Product Change Notification

Change Notification #: 110984 - 00
Change Title: Intel(R) Server Board S5520HC, S5520HCT, S5500HCV and Intel(R) Workstation Board S5520SC, PCN 110984-00, Product Design, Change CPU socket protective cover
Date of Publication: September 20, 2011

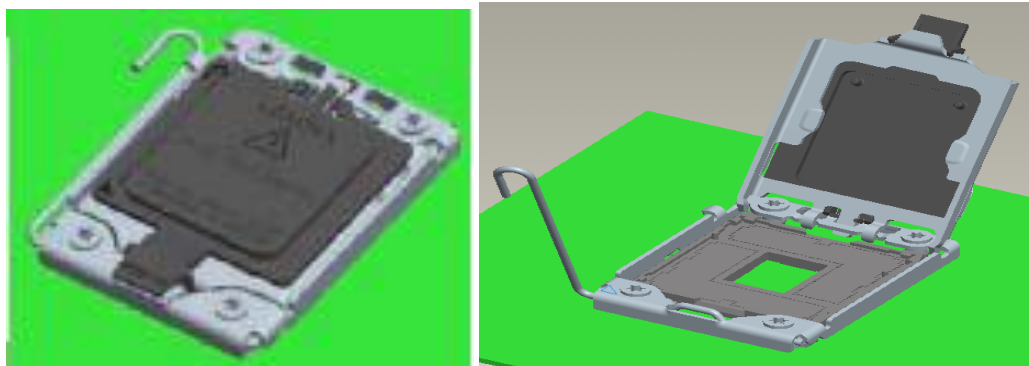
Intel will implement the following change on the Intel(R) Server Board S5520HC, S5520HCT, S5500HCV and Intel(R) Workstation Board S5520SC: Update the CPU protective cover to reduce the possibility of pin damage during processor installation. Below is a picture of the new protective plate cover:

The CPU socket protective cover change has no functional impact but may require a process change when inserting a CPU into the server board, so manufacturing documentation may need to be updated.
